Re: National Emission Standards for Hazardous Air Pollutants from Coal- and Oil-fired Electric Utility Steam Generating Units

The Clean Energy Group appreciates the opportunity to comment on the National Emission Standards for Hazardous Air Pollutants from Coal- and Oil-fired Electric Utility Steam Generating Units (EGU MACT).

Figure 2. Total HAP Metals From Oil-Fired EGUs

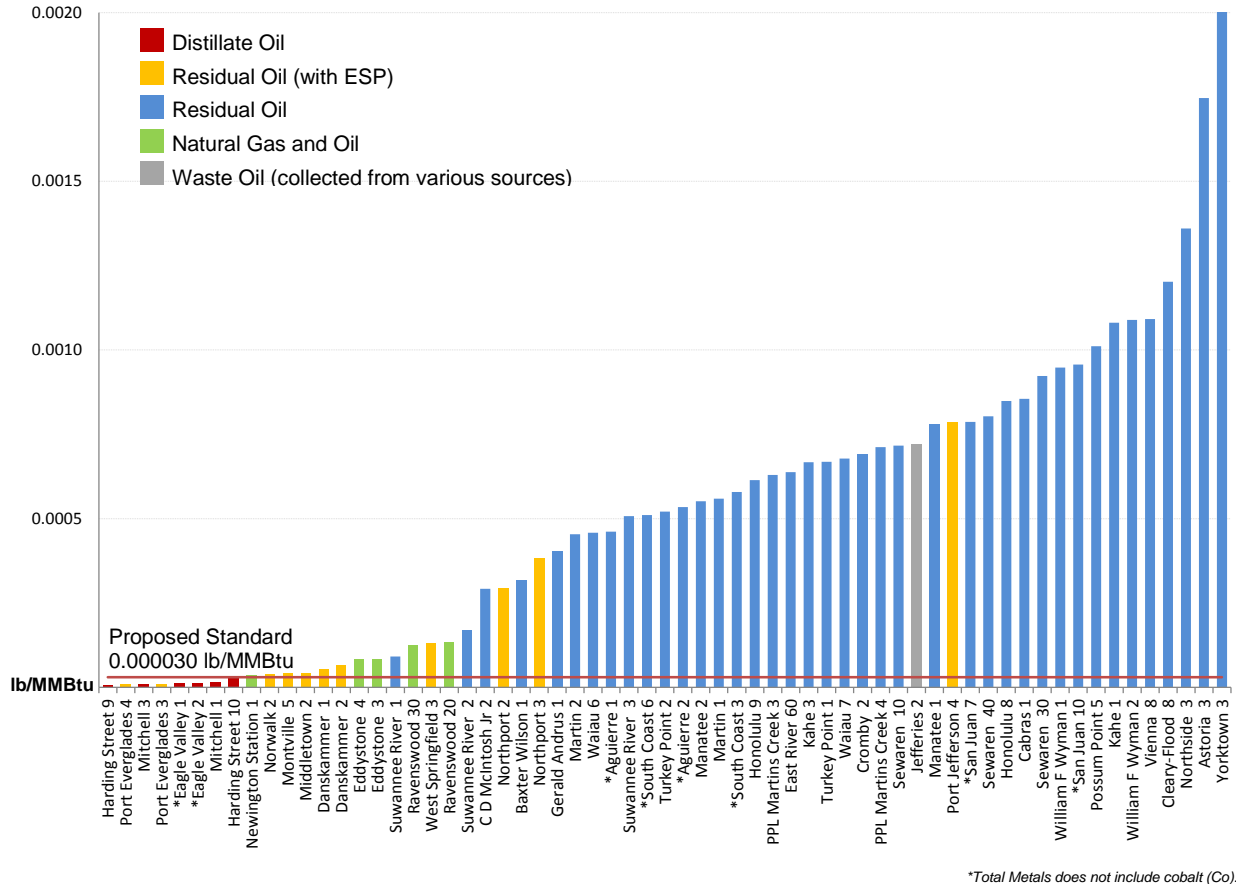
- Finally, in separate comments, NRG has submitted corrected HAP Metals emissions data for Norwalk Unit 2, Montville Unit 5, and Middletown Unit 2. The errors overstated the units’ HAP Metals emission rates.

The corrected data, to the extent that we have been able to identify problems in the database, are summarized in Figure 2 below. The current proposed standard (0.000030 lbs/MMBtu), also shown in Figure 2 below, was calculated based on seven units, most of which were burning distillate fuel oil during ICR testing. Apart from the two Port Everglades units, all of the units that established the MACT floor for Total HAP Metals were combusting distillate fuel oil. In some cases, these units were burning low sulfur distillate fuel oil. Eagle Valley, for example, specifies low sulfur (0.05%) distillate fuel oil and most shipments received by the facility contain less than 0.03% sulfur. Also, the ESPs at the Port Everglades facility were recently installed (construction was completed in 2006). However, nine units with ESPs and five units that were combusting as much as 75 percent natural gas during ICR testing report emission rates above EPA’s proposed standard (units known to be combusting natural gas during the ICR testing are shown in green in the figures below).

As shown in Figure 2, the ICR data upon which the proposed limit is based includes six units burning distillate oil, all but one of which set the MACT floor. As a result, despite the disproportionate reliance on residual oil among the sector as a whole, five distillate oil-fired EGUs were included in the calculation of the MACT floor for Total HAP Metals. This includes one or multiple units from *all* distillate oil-fired EGUs in the U.S. Therefore, despite EPA’s

intention of selecting a random sample of units, in fact the ICR database is biased toward very low-emitting units, burning distillate fuel oil. Distillate oil-fired EGUs represent more than 70 percent of the units in the MACT floor used to calculate the proposed standard. In contrast, nationwide, distillate oil-fired EGUs represent less than five percent of oil-fired EGUs within the liquid oil subcategory. This results in a standard that is contrary to the statute, which directs the Administrator to establish standards that she “determines [are] achievable for new or existing sources in the category or subcategory to which such emission standard applies.” In fact, nine units with ESPs and five units that were combusting a combination of natural gas and oil during ICR testing report emission rates above EPA’s proposed standard for Total HAP Metals. Taken together with the fact that one distillate unit, Harding Street 10, tested essentially at the standard without a compliance margin, there is no clear path to compliance with the standard as proposed.

The Clean Energy Group recommends that EPA post a revised spreadsheet on the Utility MACT website, reflecting the corrections above and any further corrections identified by other commenters.

Figure 3. HCl from Oil-Fired EGUs

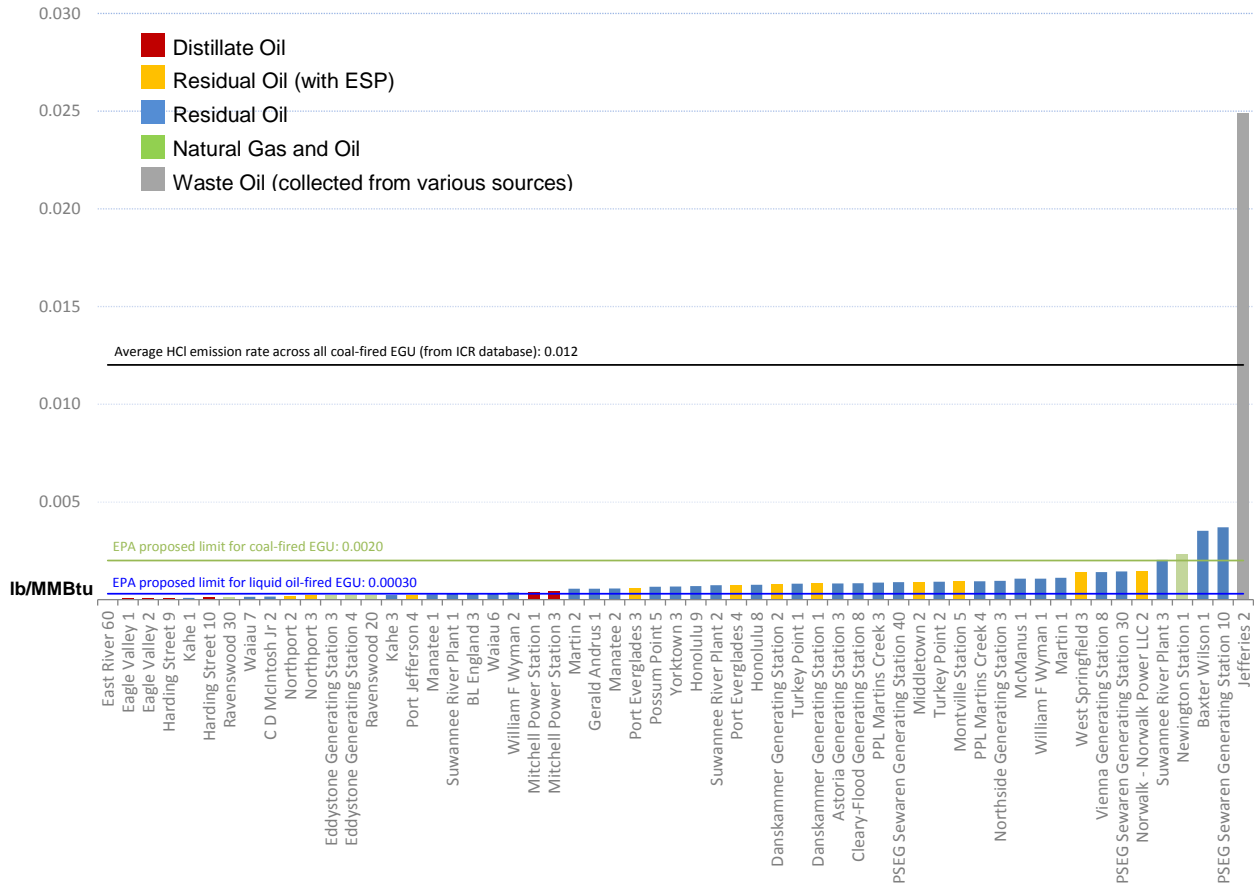
Figure 3 summarizes the HCl emissions data reported under the ICR. With the exception of Jefferies 2, which was burning waste oil during the ICR testing, all of the liquid oil-fired EGUs report low concentrations of HCl emissions. (EPA's proposed standard for existing coal-fired EGUs and the average HCl emission rate reported by coal-fired EGUs are provided for context.) Unlike the Total HAP Metals, there is no clear pattern in terms of the units meeting the proposed standard. There are units with ESPs, units combusting residual fuel oil, units combusting distillate fuel oil, and units co-firing natural gas both above and below the proposed limit for HCl. Also, we would emphasize that there are no installed or demonstrated control technologies for limiting HCl and HF emissions from liquid oil-fired EGUs, as there are for the other HAPs regulated under the proposed rule.

As further context, we calculated the potential annual emissions of HCl from the oil-fired EGUs that participated in the ICR. Virtually all units were found to emit HCl at levels below the major source threshold. Table 2 illustrates that the vast majority of the oil-fired boilers that participated in the ICR testing would emit HCl at levels well below the major source threshold of 10 tons per year for any individual HAP—particularly when we assume the low to intermediate utilization rates common among residual oil-fired boilers.

As discussed above, we recommend that EPA set a percent water content limit for oil, rather than setting HCl and HF emissions limits for liquid oil-fired EGUs. ASTM test methods are available for measuring the percent water content of fuel oil (D95 and D473). Plant operators would test each shipment received to ensure compliance with the proposed limit.
